Development Review Division

SUBJECT: SUB20-002, Douglas 234 Filing 6 – Minor Development Plat Review Comments v2

A REPLAT OF LOT 1, BLOCK 10, DOUGLAS 234 FILING NO. 1, BEING LOCATED IN SOUTHEAST QUARTER OF SECTION 29, TOWNSHIP 6 SOUTH, RANGE 66 WEST 6TH P.M. TOWN OF PARKER, COUNTY OF DOUGLAS, STATE OF COLORADO SHEET 1 OF 2

LANDSCAPE AND IRRIGATION PLANS
DOUGLAS COUNTY 234
FILING NO. 6
DOUGLAS COUNTY, COLORADO

MAJOR MONUMENT SIGN

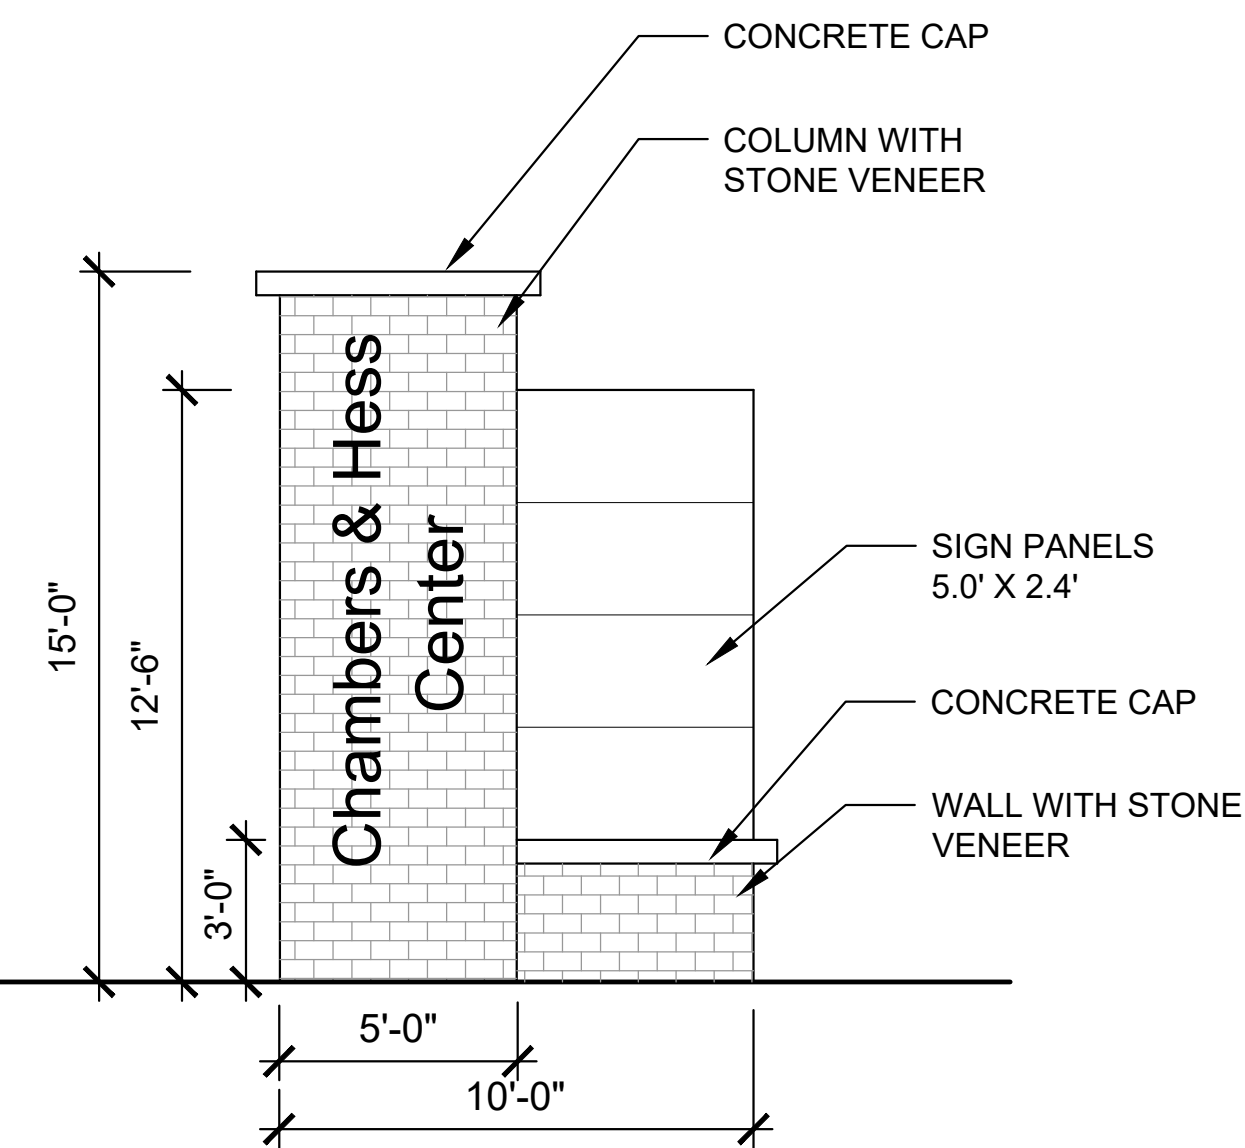
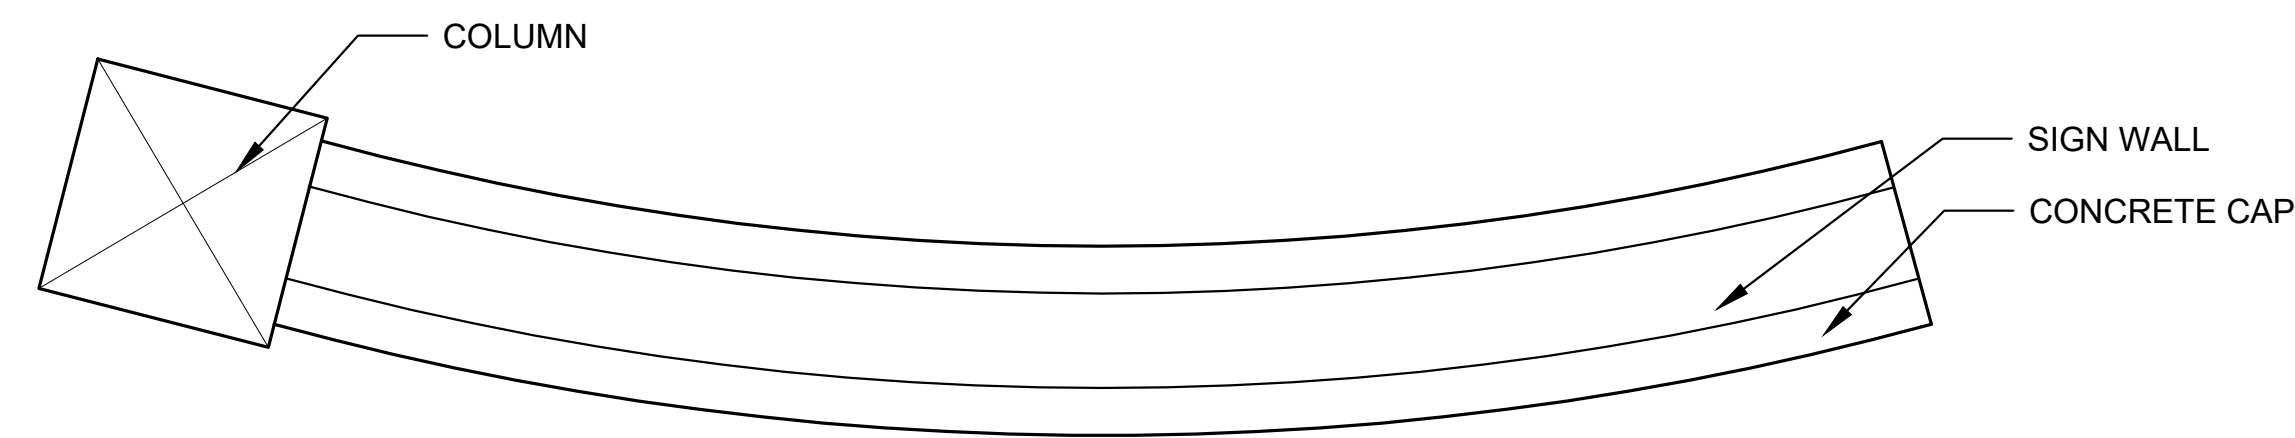
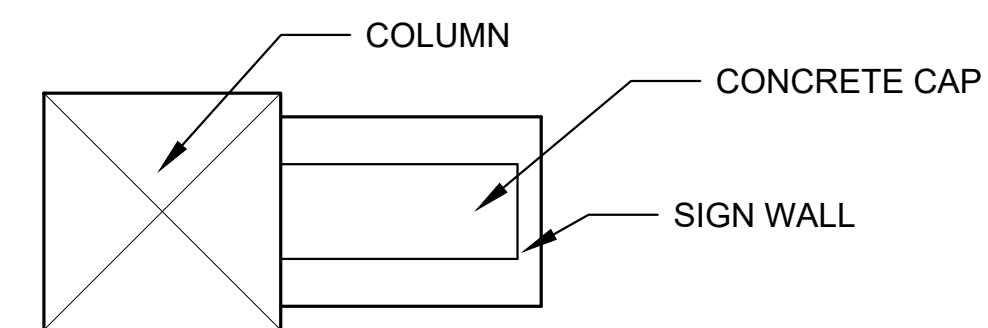
Please add note that signs will be reviewed under separate permit.
Please add note to all appropriate pages.

NOTE ADDED. -RICK
